Chapter 3

Original Mandatory Referral

Mandatory Referral Site Plan Staff report

REVIEW TYPE: Mandatory Referral
PROJECT NAME: Takoma Park Community Center
APPLICANT: City of Takoma Park
CASE NUMBER: 02101-TP-1
REVIEW BASIS: Article 28, Chapter 7-112 of the Regional District Act
ZONE: R-60
MASTER PLAN: Takoma Park Master Plan
FILING DATE: June 5, 2002

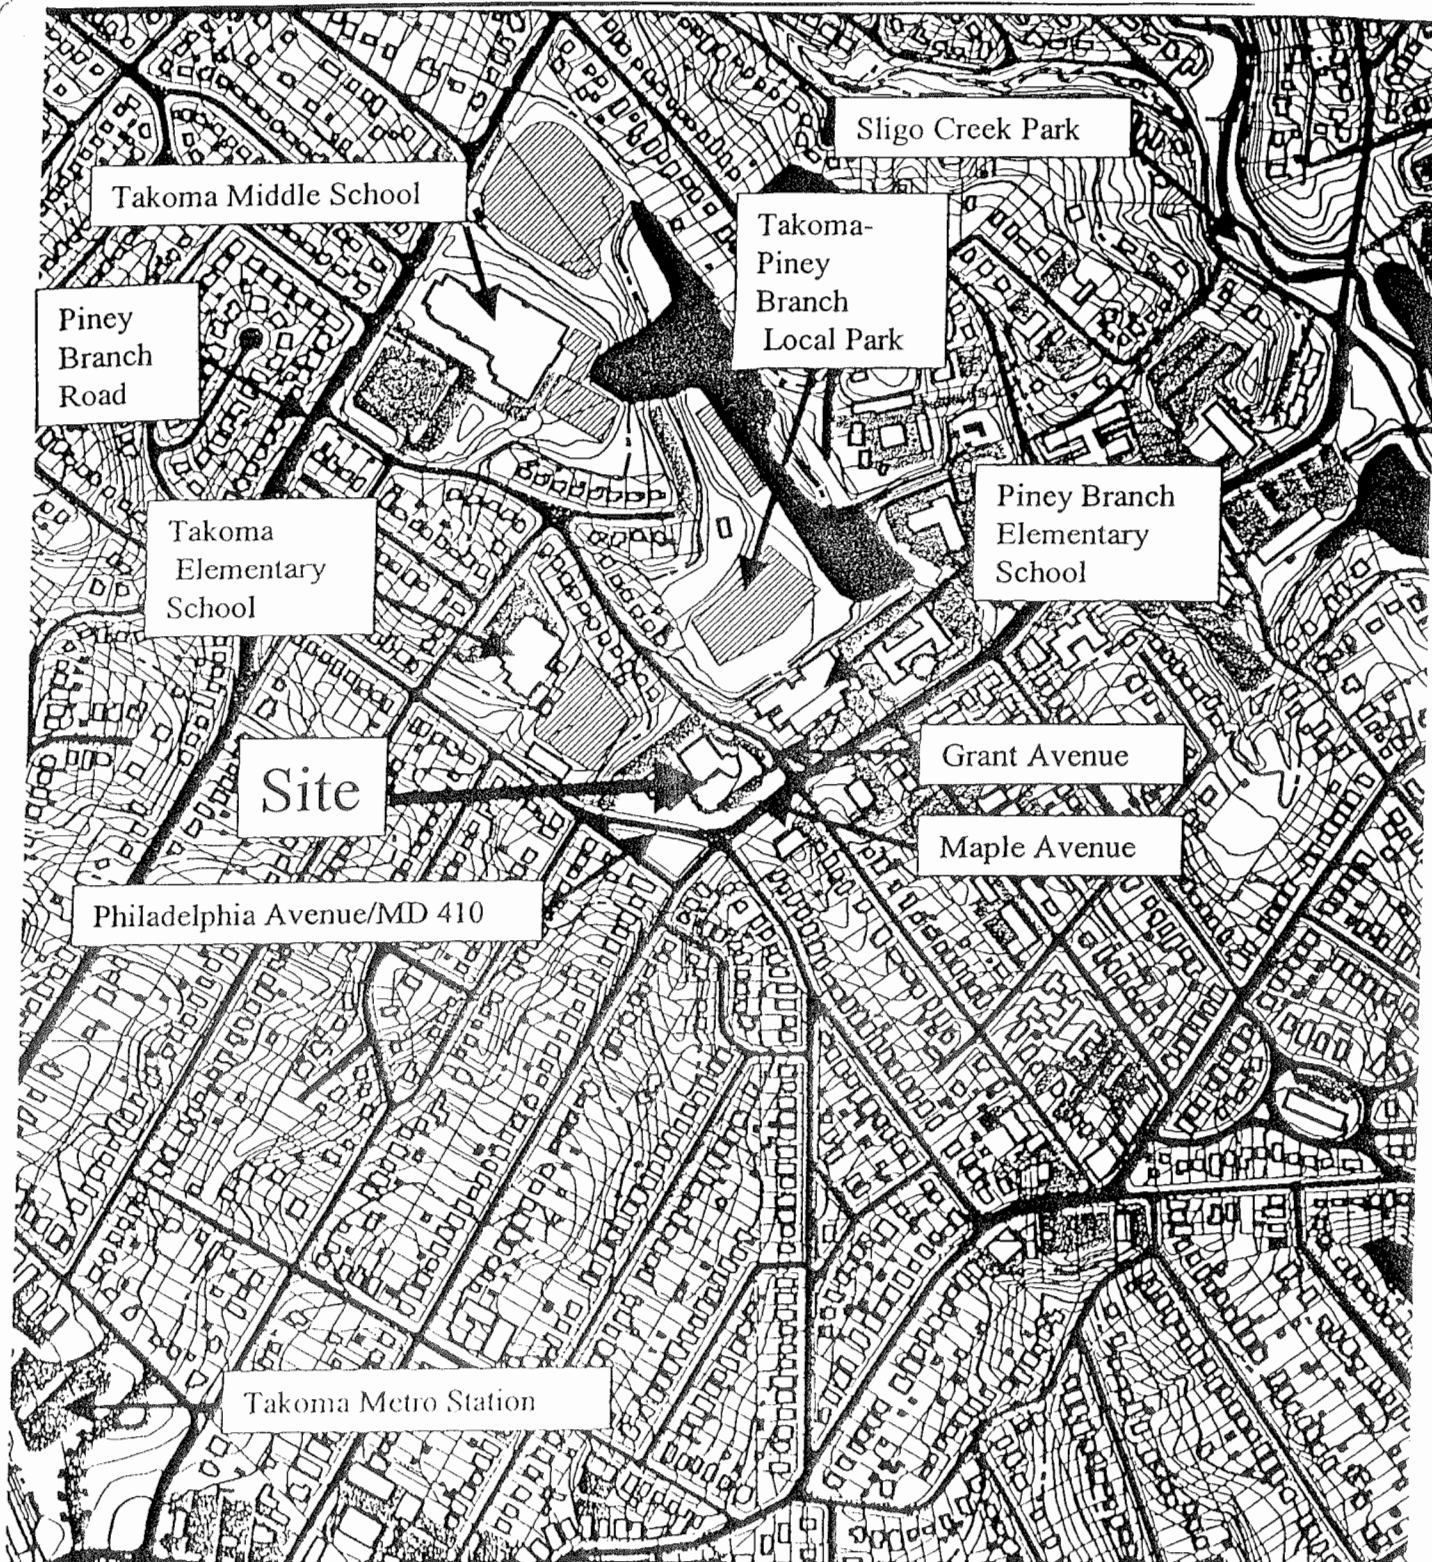
The City is requesting the conveyance of approximately 0.5 acre of parkland at the edge of Takoma Piney Branch Local Park. This will allow the City to build within what is currently the Grant Avenue right-of-way and to grade and terrace a slope that is currently parkland. This will allow the access drive for the parking facility and a corner of the gymnasium to be built outside of what is today the City's parcel.

The City is also proposing changes to the park slope to facilitate construction of the access drive. The slope will be quite visible to users of the new Community Center and the park, and will be terraced, landscaped, and maintained by the City as part of the site. The following comments are recommended:

1. ^{conditions} Prior to conveyance of parkland, the City of Takoma Park and the M-NCPPC shall enter into an agreement providing for the City to make certain improvements to the existing park entrance and slope on Grant Avenue. Construction for the entrance is to be determined based on a fair exchange for the value of the parkland. Construction shall occur as part of Phase 2 of the Community Center Construction. As part of this agreement the City shall provide a concept design for an attractive new entrance to the park from Grant Avenue with access for pedestrians, bicyclists, and emergency and maintenance vehicles, and design and construction drawings.

2. The City of Takoma Park shall submit site, landscape, lighting, and stormwater management plans for these improvements to the M-NCPPC for review and approval prior to applying for a building permit. The City shall obtain a park permit prior to construction.

3. The City of Takoma Park shall remove invasive species, provide a tree preservation plan, and stabilize slopes in the area to prevent erosion.
4. The City of Takoma Park shall officially abandon adjacent road right-of-way and record new plats to reflect the road abandonment and park conveyance.

Site Plan with Comments

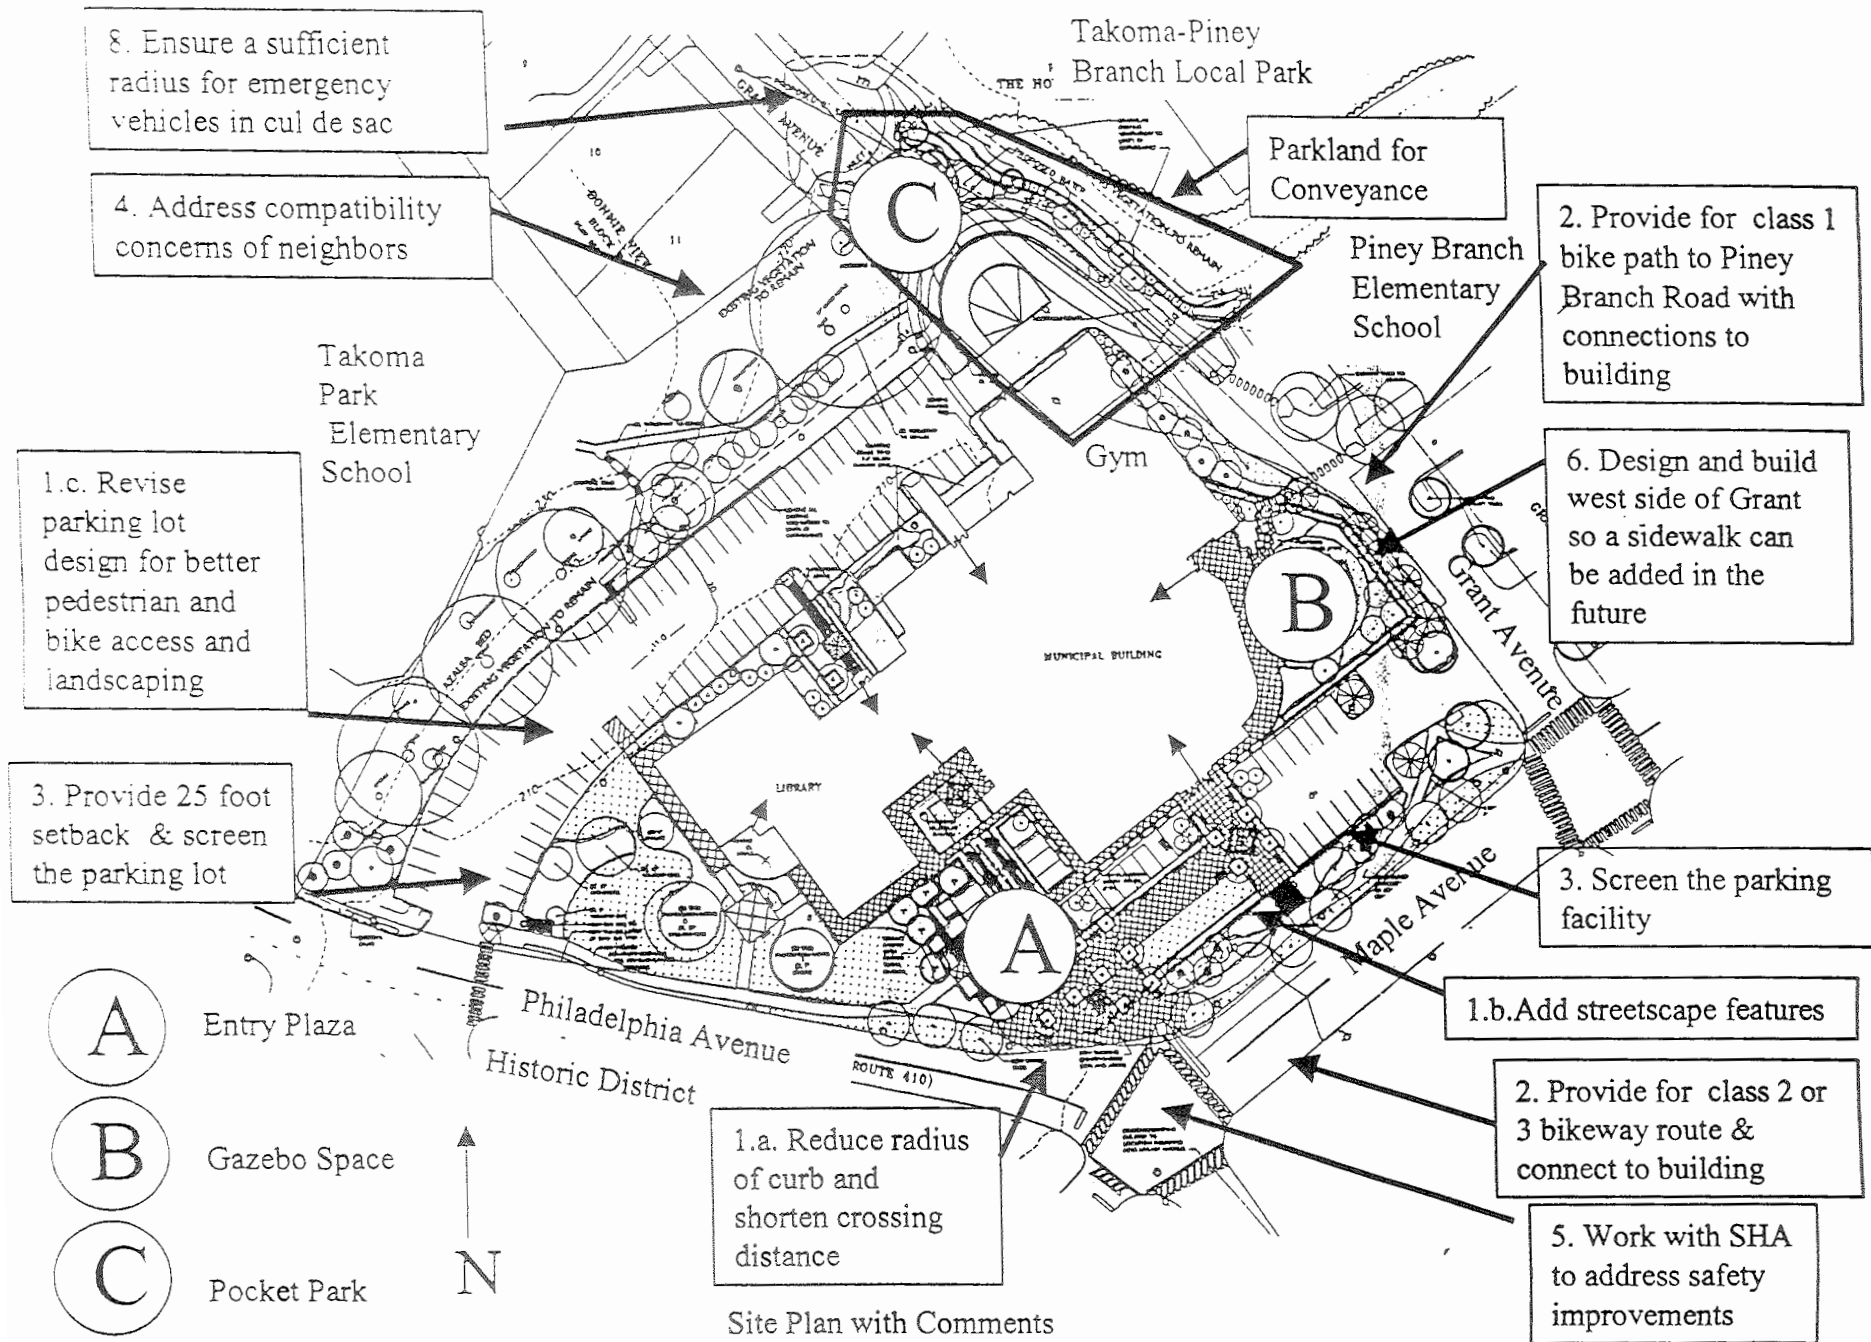
1. Address the following pedestrian access issues:
 - a. Reduce the radius of the curb at the corner of Maple and Philadelphia Avenues and narrow the pavement to the minimum allowed to shorten the crossing distance for pedestrians. Coordinate with State Highway Administration.

- b. On Maple Avenue, incorporate additional streetscape features such as seating areas, enhanced crosswalks, and decorative lights.
 - c. Revise the parking lot design to reflect better pedestrian and bikeway access and additional landscaping. Consideration should be given to reducing the number of spaces shown to accommodate the improvements (up to approximately 10%).

- d. Strengthen and enhance the pedestrian circulation, particularly to improve the connections between the open space and to enhance access to the building, as described in the body of this staff report.

- a. Four surface parking spaces near the Philadelphia Avenue entrance should be either relocated or removed to provide a 25-foot setback consistent with the development standards in the zone.
 - b. Screening for the parking facility as described in the Zoning Ordinance should be provided along Philadelphia Avenue, Maple Avenue, and Grant Avenue.
4. Address compatibility issues with neighbors on Grant Avenue by providing for tree preservation and supplemental planting as appropriate along the slope. Select and locate lights to minimize intrusion into homes.
 5. Work with SHA to address safety improvements along Philadelphia Avenue at the Main Entry Plaza.
 6. Design and build the west side of Grant Avenue so that a sidewalk can be added in the future by the City.
 7. Ensure a sufficient radius for emergency vehicles for the proposed redesigned cul-de-sac on Grant Avenue.

Buildings: The placement works well on the site provided the parkland conveyance is approved. One safety consideration is that the route to the park along Grant Avenue is opposite the blank wall of the gymnasium where there are no windows looking out on that area. Consideration should be given to organizing the building spaces to ensure that there is an active interior space with windows looking out on this route to and from the park.

Open space & pedestrian circulation: There are three main areas of open space: The Entry Plaza, the Gazebo Space, and the Pocket Park. Collectively, the amount of open space is adequate and is distributed well throughout the site. Pedestrian connections between the spaces and to the public realm of the streets should be strengthened. Maple Avenue, as the civic main street, Grant Avenue as the route to the park and "seam" to connect to Piney Branch Elementary School next door, and Philadelphia Avenue as a main thoroughfare and major transit route should all have strong and welcoming connections to the public gathering spaces associated with this town hall/community center.

Vehicular Circulation: The vehicular access to the parking areas works well. The use of three parking spaces for loading as proposed is acceptable. The design should ensure that a sufficient radius is provided for emergency vehicles to maneuver within the proposed new cul- de-sac at the end of Grant Avenue.

Site Plan with Comments regarding Pedestrian Circulation

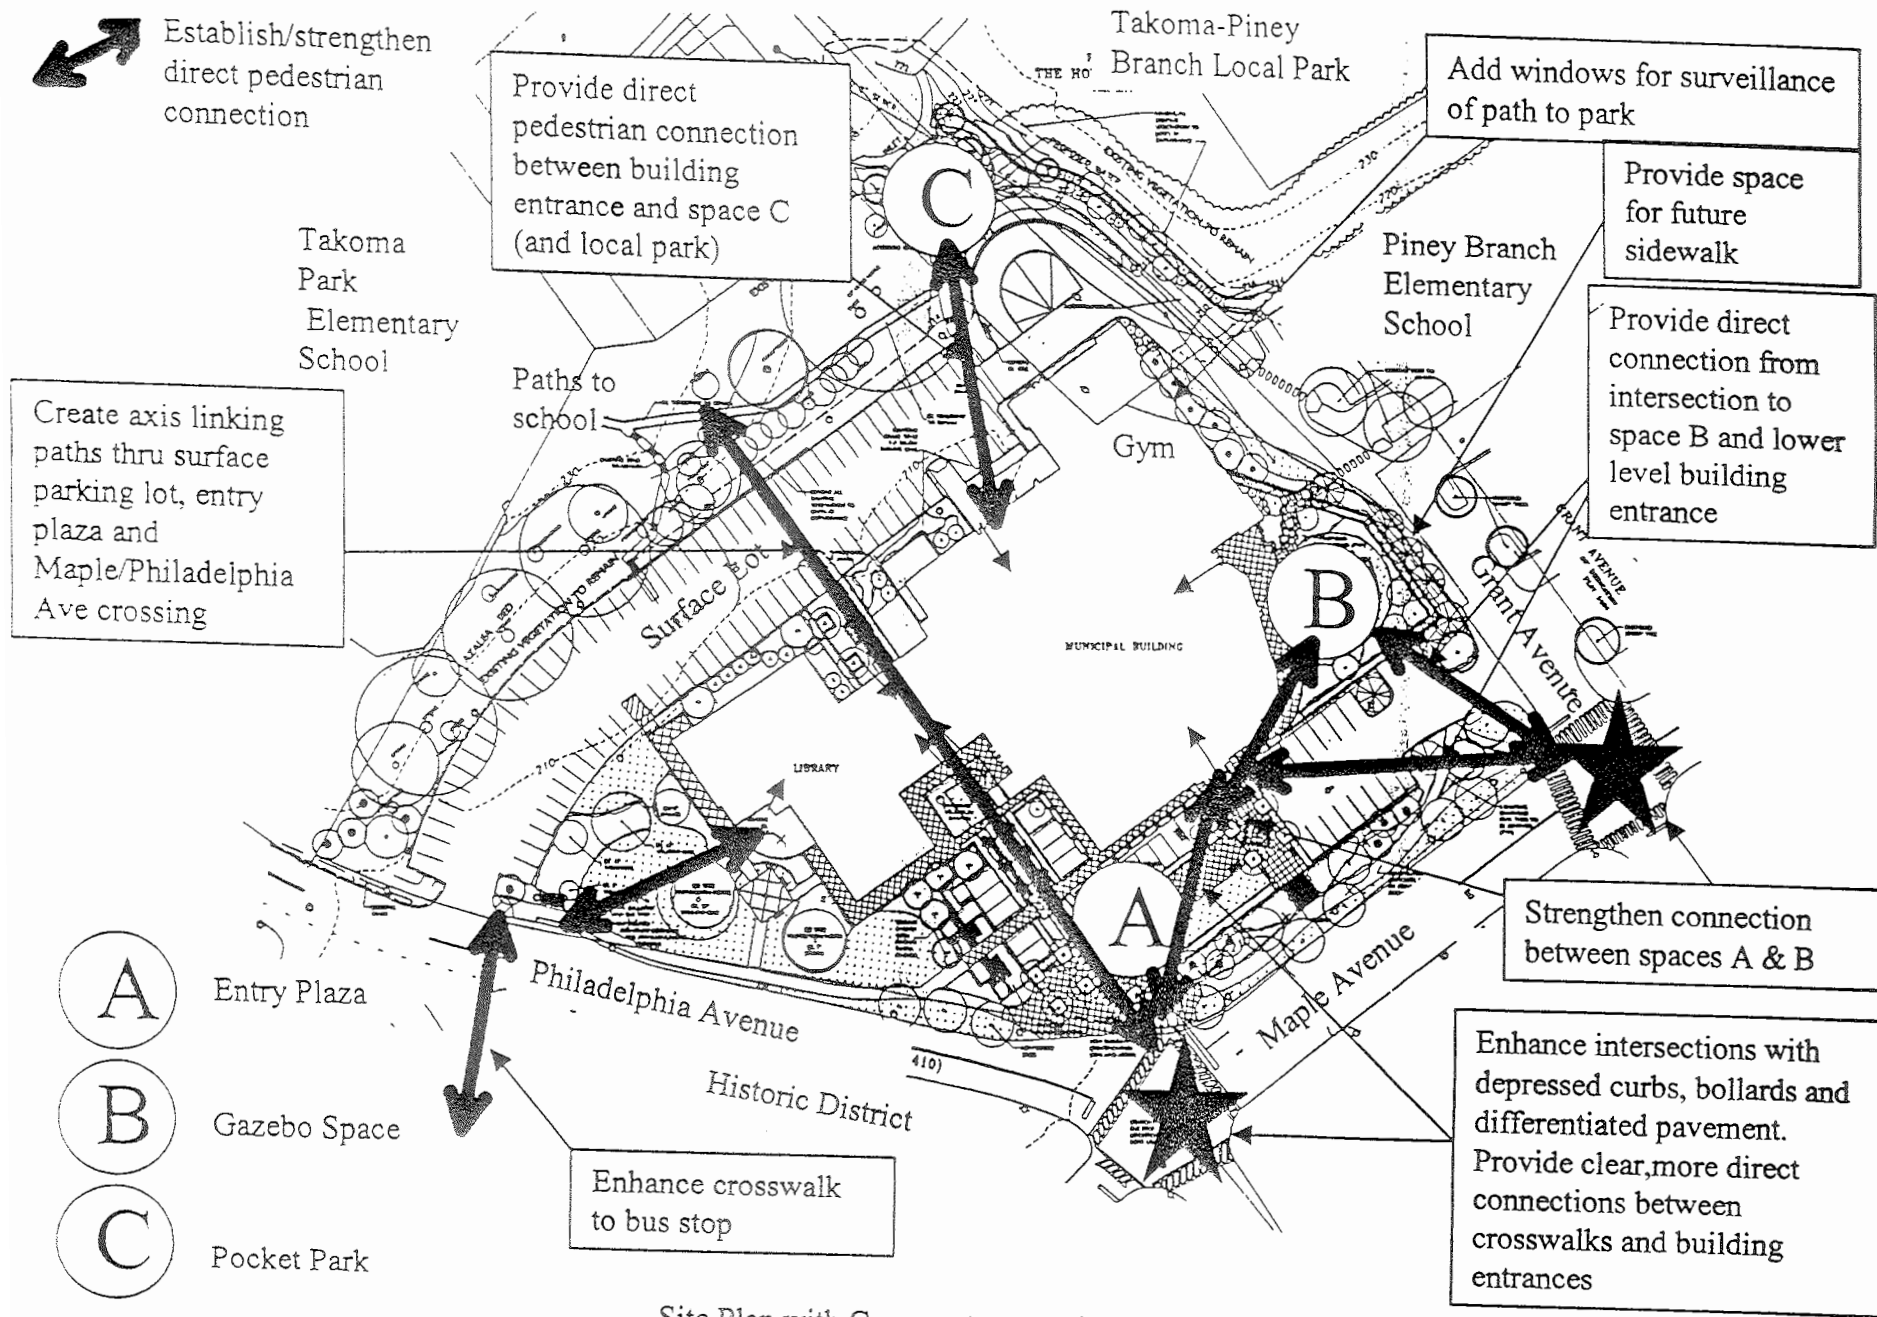
In addition, the intersections with Maple Avenue should be improved by reducing the crossing distance for pedestrians. The radius of the curb could be reduced to 30 feet. Differentiated pavement and enhancements to Maple Avenue should be considered at both the Philadelphia Avenue and Grant Avenue intersections. The proposal shows a depressed curb with bollards at the intersection with Philadelphia Avenue for better bicycle and pedestrian access and to create a stronger plaza presence within the community. A similar treatment should be considered at Grant Avenue and Maple Avenue.

In addition, pedestrian routes from the crosswalks to the two building entrances should be clear and more direct. For example, consideration should be given to creating a pedestrian axis from the corner, on a straight line through the plaza, through the building entrance near the library, and then to an attractive pedestrian entrance for the surface parking lot beyond. The route to the main entrance from the crosswalks should be direct and take into consideration the view lines that are created for pedestrians moving through the plaza to and from that entrance.

A stronger connection between the surface parking lot and the open space is also desirable. The above revisions will provide for a better visual and pedestrian link between the two.

- On the north side of the building, continue paths from Takoma Park Elementary School and Grant Avenue, across the surface parking lot to connect to the community center entrances. Enhance the site design associated with the entrances so they are highly visible.

- On the South side provide direct pedestrian access from Maple Avenue and Grant Avenue to the building entrances on ground level with clearly marked crossings, pavement, and signs.

- On the west side investigate creating an enhanced crosswalk on Philadelphia Avenue for transit users.
